PRODUCT CHANGE NOTICE

| Notification Number | PCN 106 |
| Change Subject | Endura QZ35Q and JD35Q Product Change |

Photo of board with LAN heatsink installed

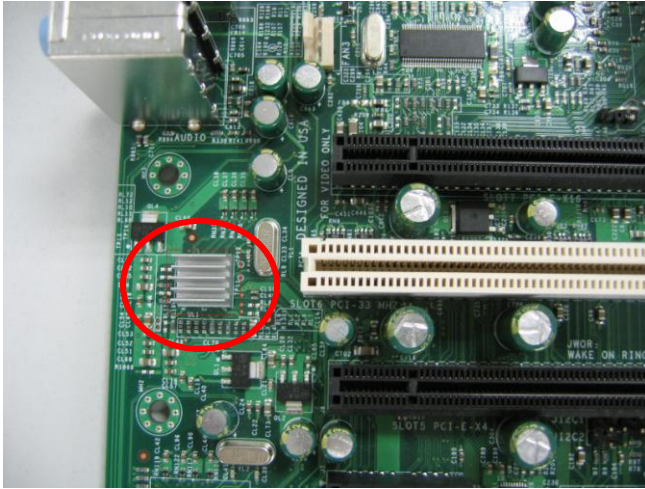
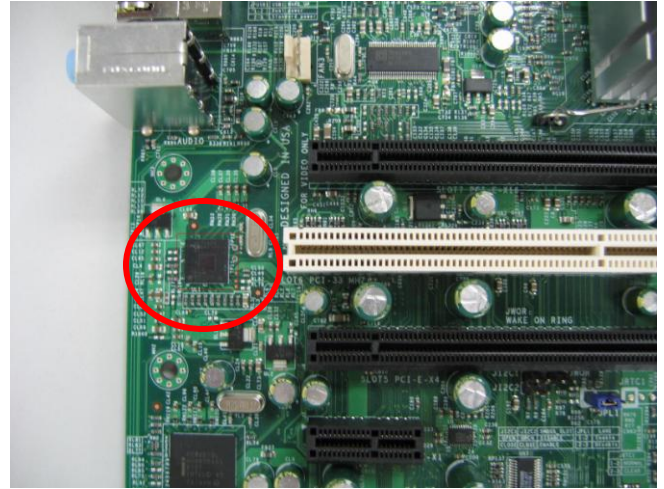
The heatsink on the LAN 82566 chip is being removed to prevent a mechanical conflict while using a PCI card. The heatsink is an unnecessary component and is not needed for thermal management by the LAN chip. Photos of the heat sink (1) installed and (2) removed are show for your reference on the next page.

No action is required. The heatsink will be removed after existing inventory is shipped. There will be no rework of current inventory (removal of the heatsink). You may remove the LAN heatsink from the boards listed below and the RadiSys warranty will remain valid. If you have questions, please consult with your RadiSys FAE or contact RadiSys Technical Support.
